MUNICIPAL REVISE PERMIT AND INSPECTION RECORD 03/17/2025
MUNICIPAL NO.2024-045077 FOLIO: 3220220090010
JOB SITE ADDRESS 7900 NW 154 ST
PROPOSED USE OFFICE - PROFESSIONAL BUILDINGS
LEGAL MIAMI LAKES BUSINESS PARK SEC 1 PB 126-54
APPLICATION TYPE ALTER INTERIOR 23000 SQFT 0 UNITS 0 FLOORS
OWNER NAME HUNDREDFOLD HOLDING 7900 LLC
CONTRACTOR CAMCON GROUP LLC
QUALIFIER
PERMIT TYPE MUNICIPAL BLDG
CATEGORIES 0001 MUNICIPAL GENERAL BUILDING

WARD LAW GROUP
7900 Miami Lakes Dr, Ground Floor
Miami Lakes, FL 33016

Please find below a written narrative of Revision 10 to the Ward Law Group, Ground Floor Renovation. Revisions were due to comments received Miami Dade Fire Department and Electrical. Please let us know if there are any questions, comments, or concerns.

Ward Law Group-Response to Comments-Rev 10 RWK 2025-03-07.pdf

ENLARGED PLANS & ELEVATIONS - STAIRS 159

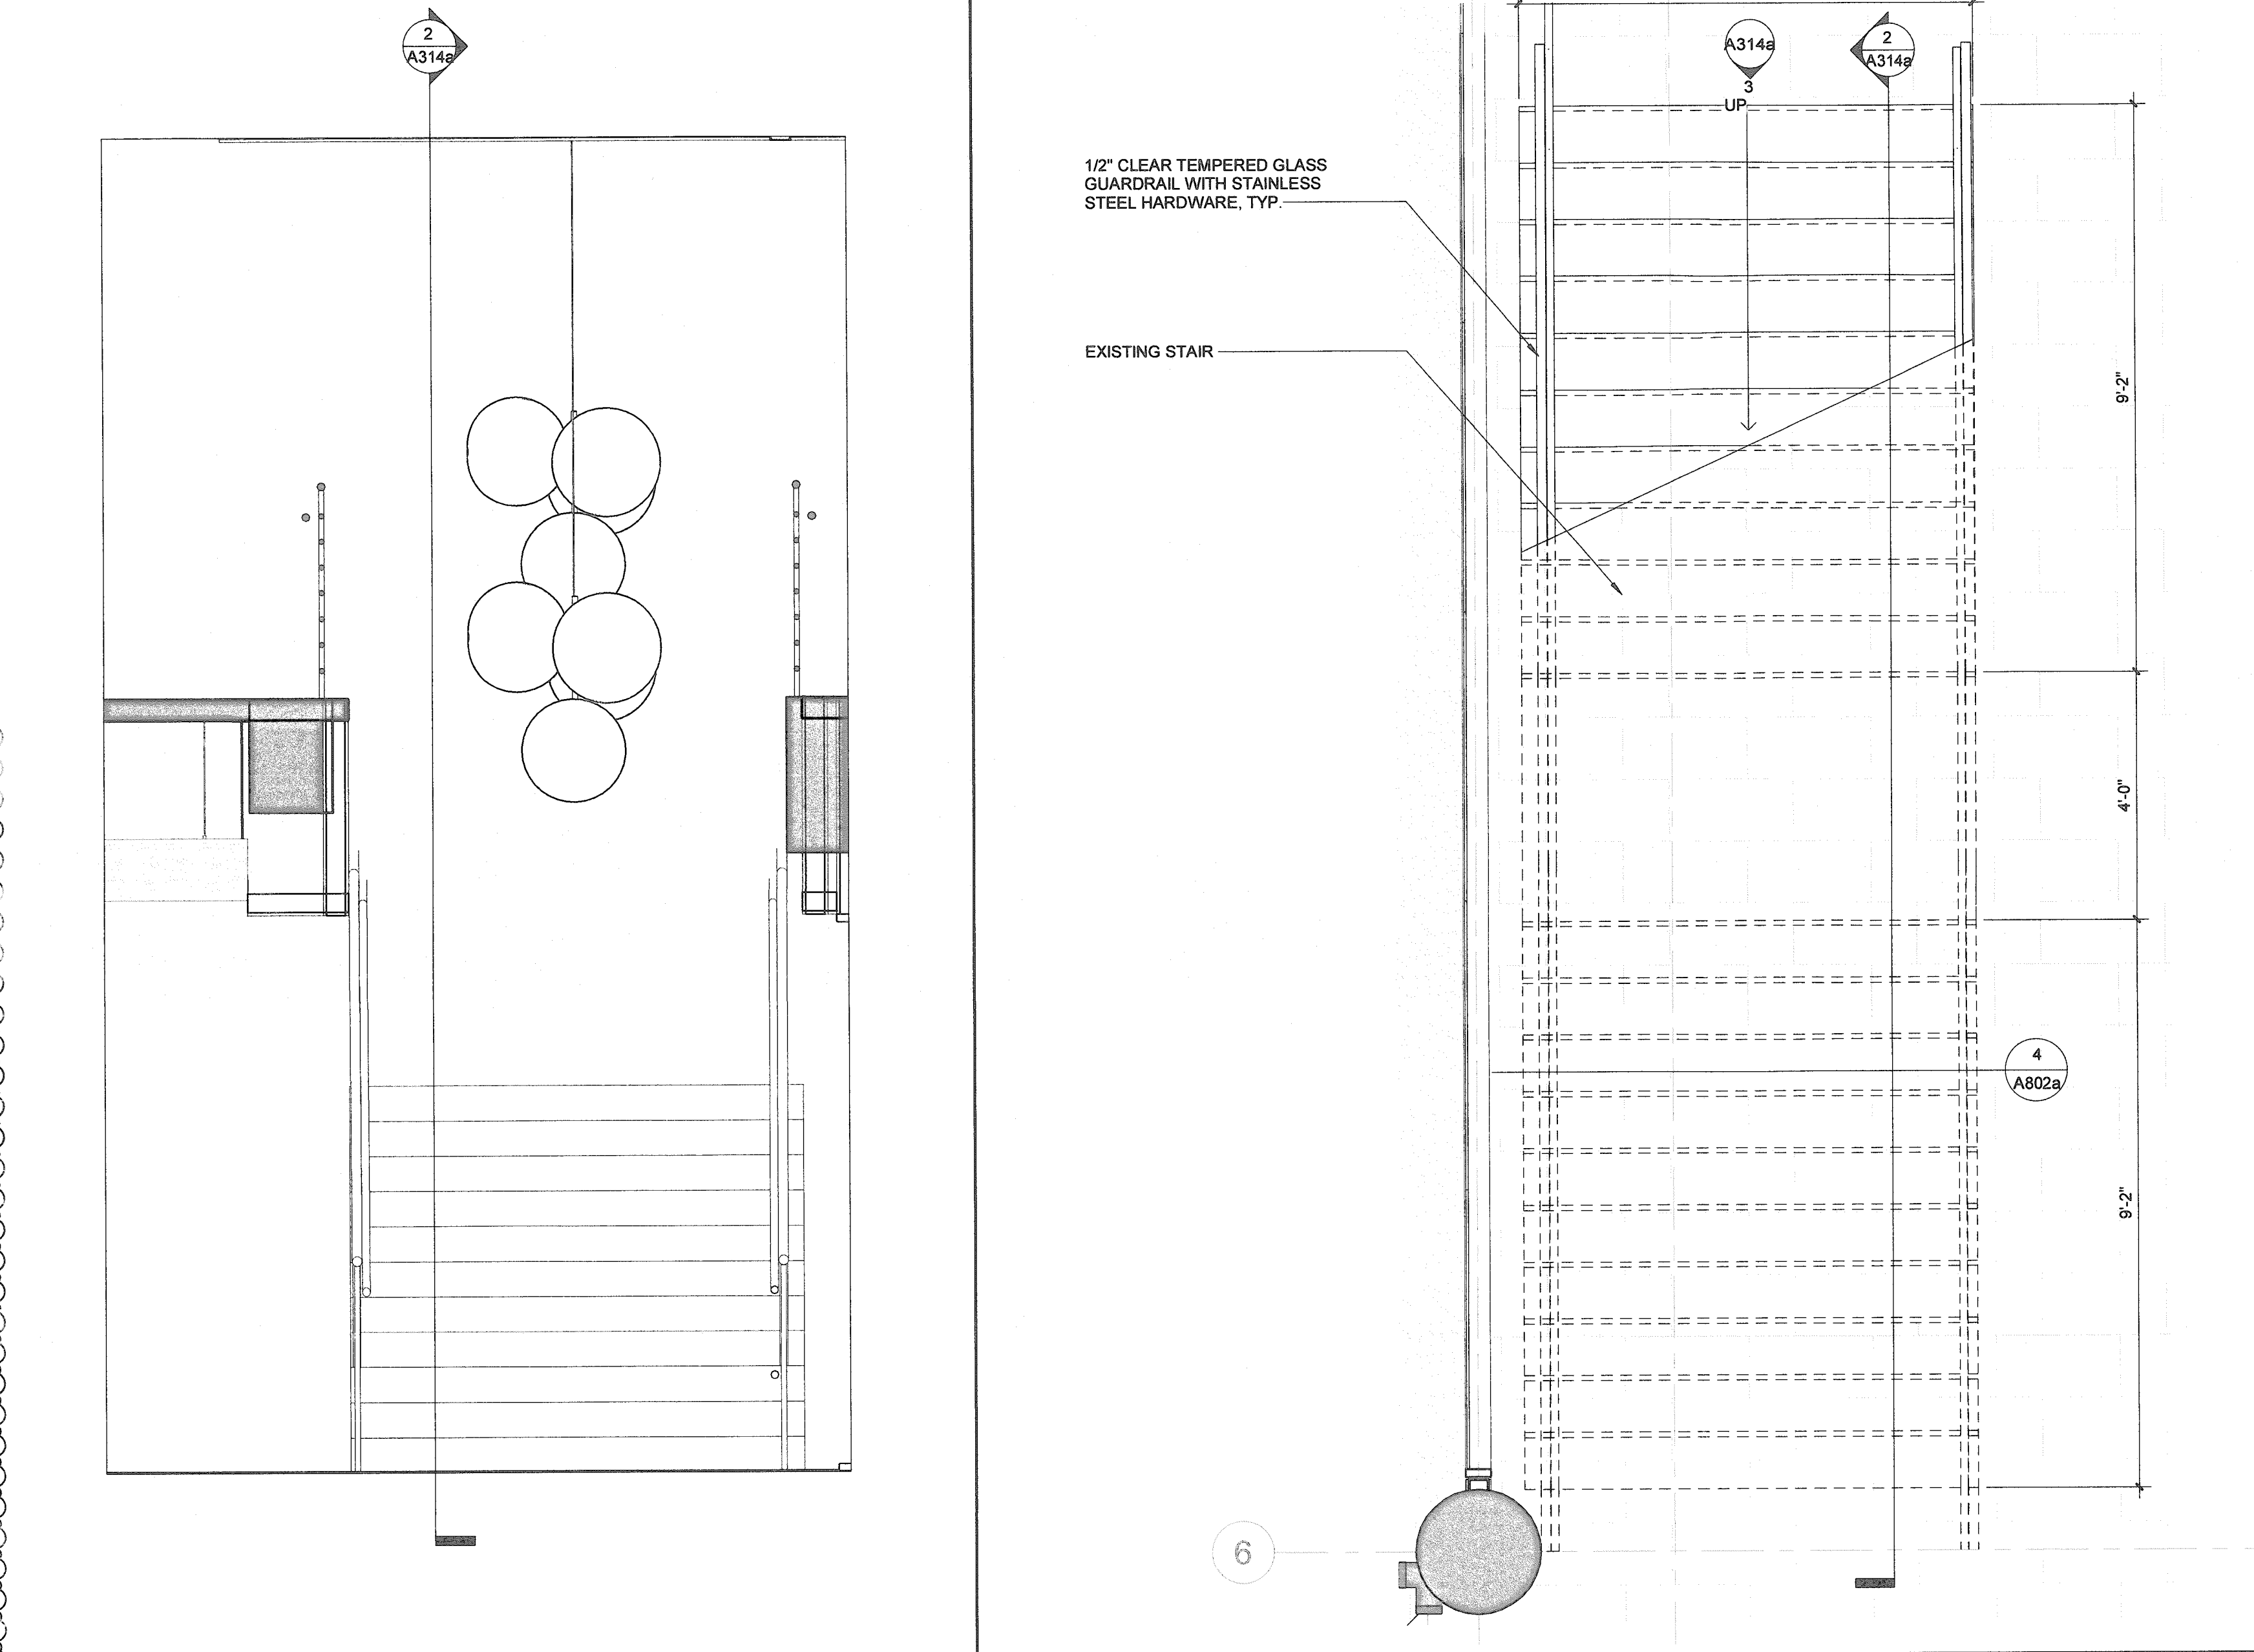
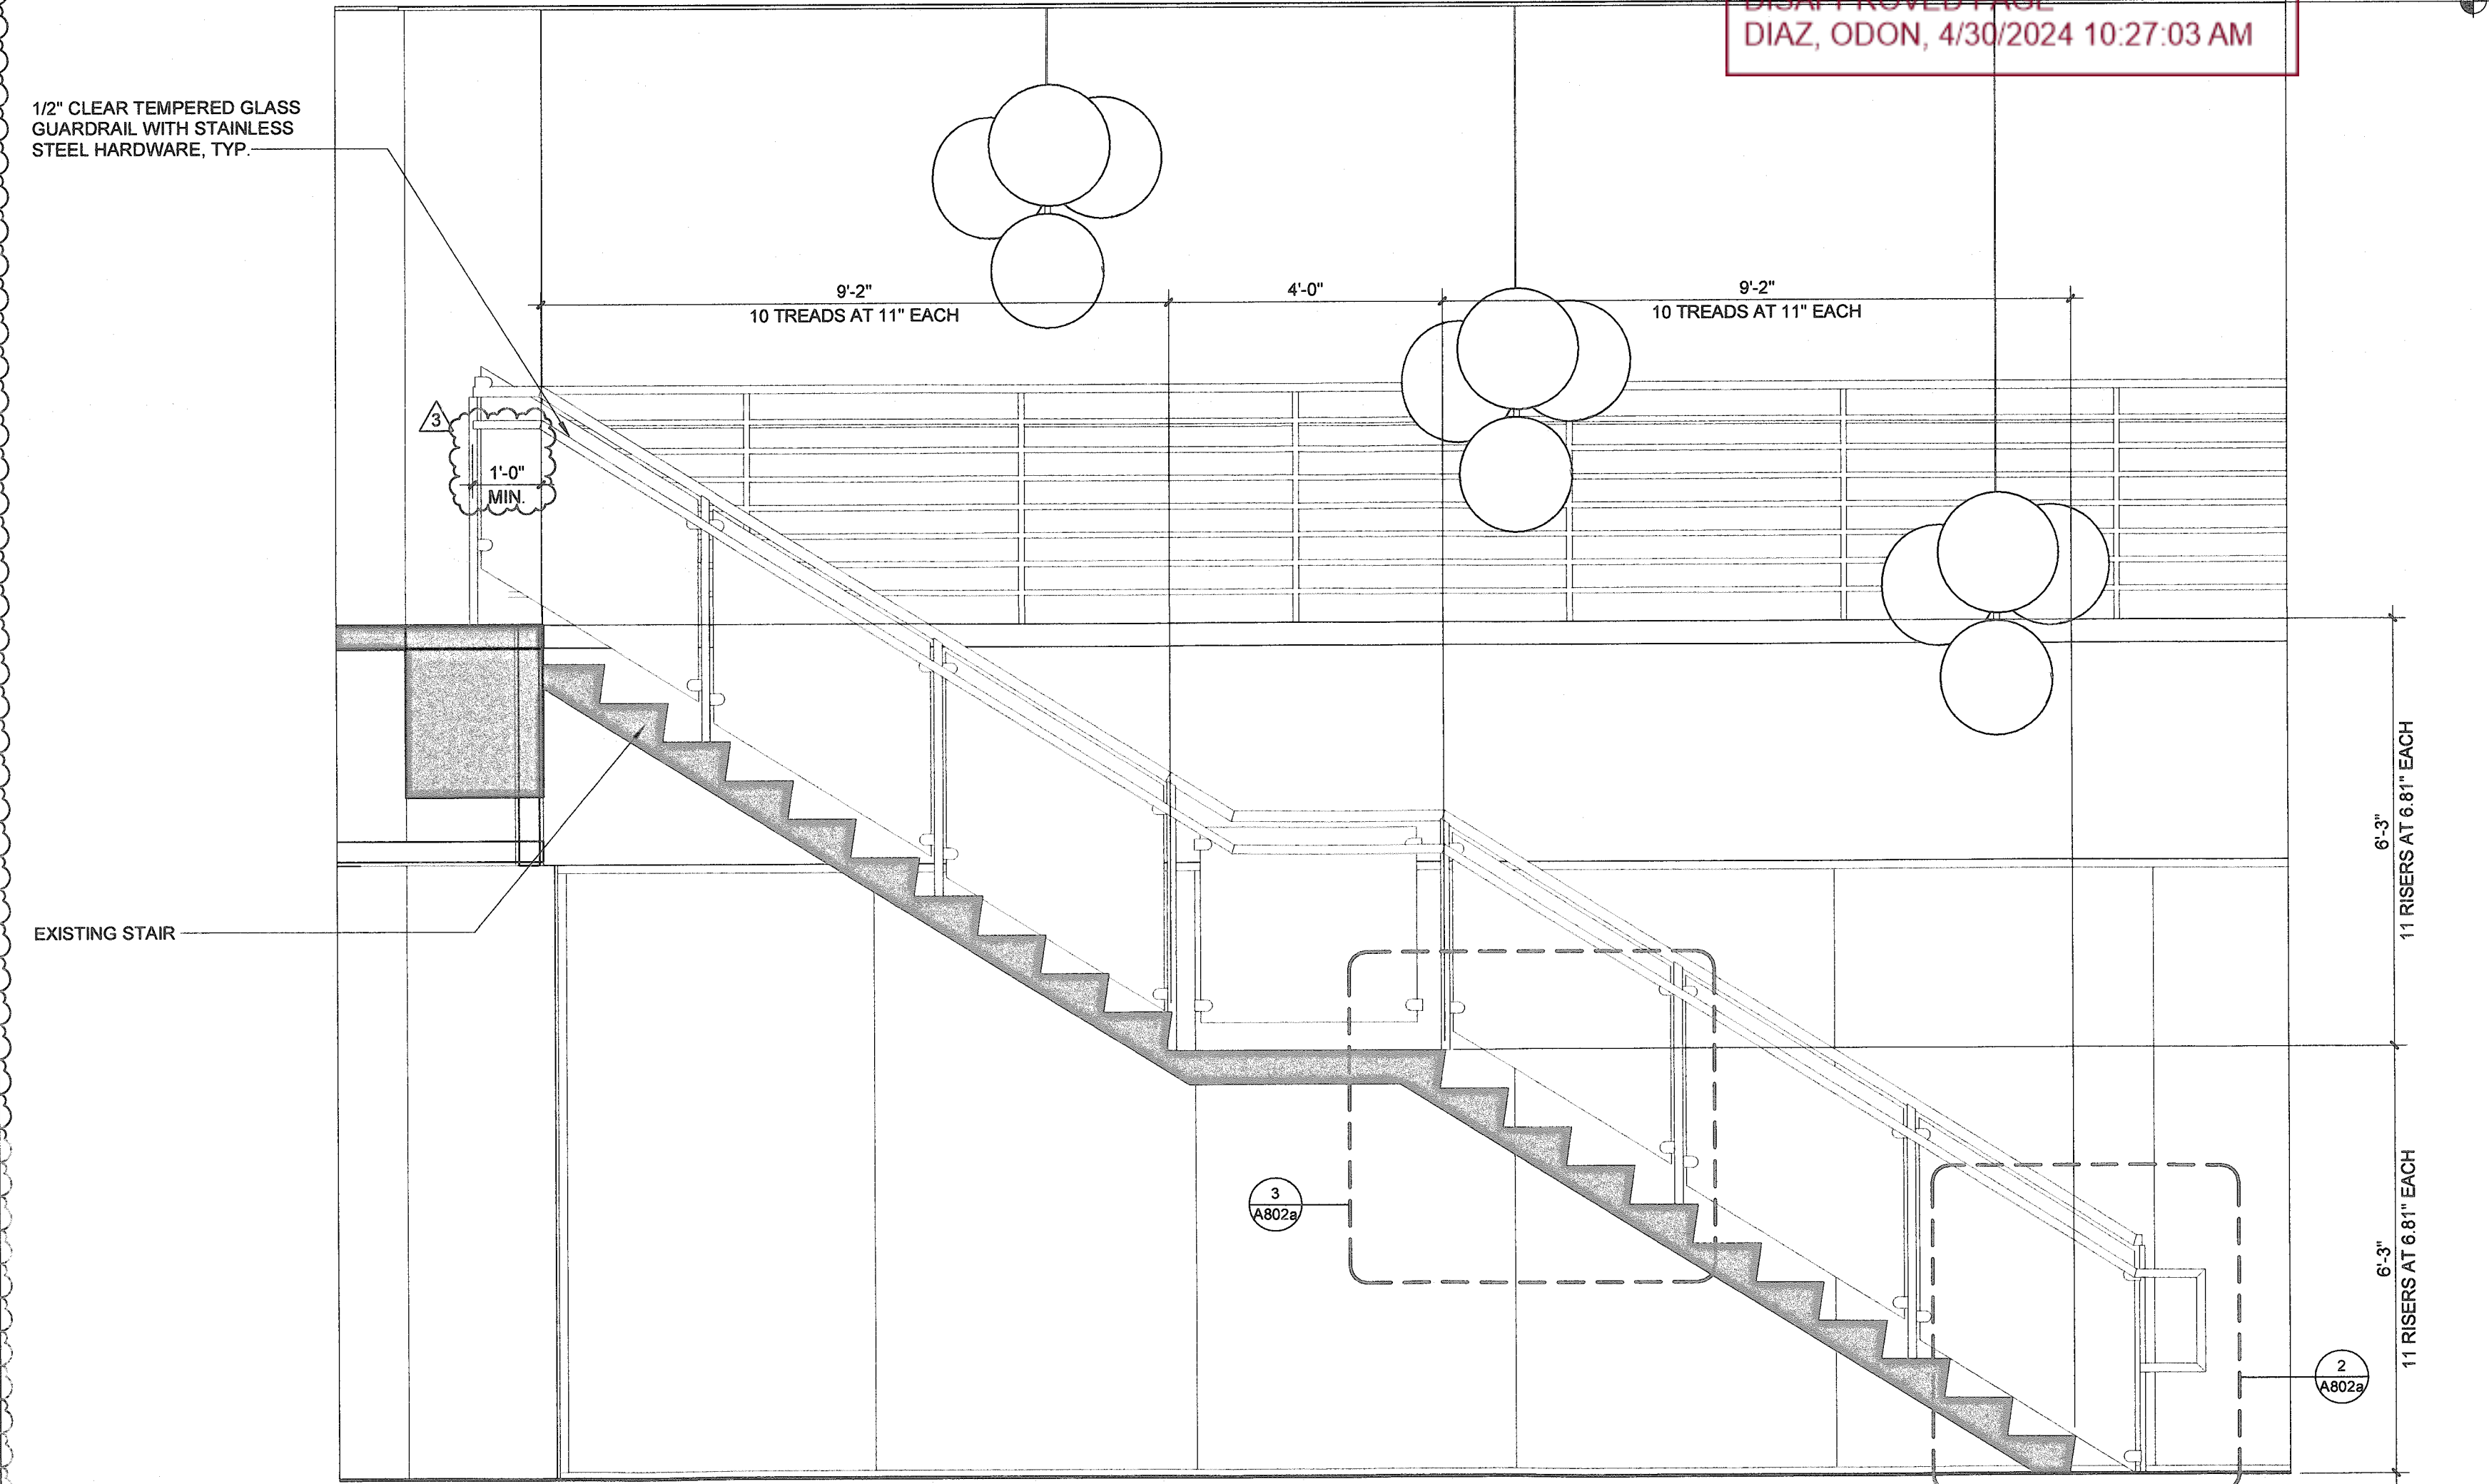
MDFR NOTE: EXISTING UNPROTECTED VERTICAL OPENING NOT IN COMPLIANCE WITH FFPC 101.38.3.1 TO BE CORRECTED UNDER SEPARATE PLANS PER AGREEMENT WITH AOR. 04/30/2024 MEETING.
